Thicker Fuel Pump Check Valves – 1991 40 thru 275

Mariner and Mercury Starting Serial Number	US	Belgium
40, 50/60 (4 cyl.)	OD048673	OG660394
75-90	OD055949	OG660394
100/115	OD055683	OG660394
135-200	OD056651	
275	OD057353

Figure 1
QUICKSILVER:

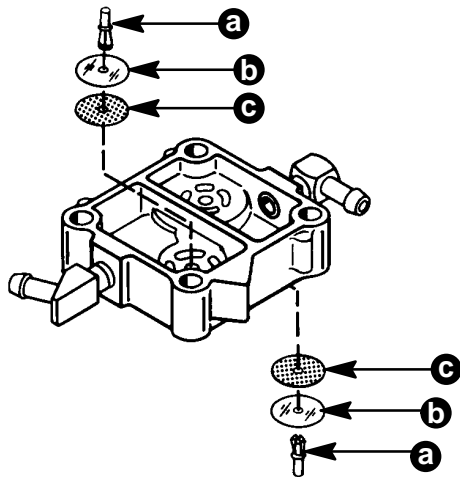
Previous rubber fuel pump check valves had the potential to be partially pulled into the fuel passage way of the fuel pump body. The result is the outboard may surge (partial reduction in fuel flow) or, in an extreme condition, not run (complete loss of fuel flow).

A mid-year product improvement change increased the thickness of the check valve from 0.017 inch (0.43mm) to 0.030 inch (0.77mm). When replacing a check valve that has been pulled into the fuel passage way, install a new fuel pump diaphragm kit listed which has the thicker check valves.

All existing inventory of the fuel pump diaphragm kits were reworked. The previous kits supersede to the new kits listed which have the thicker check valves.
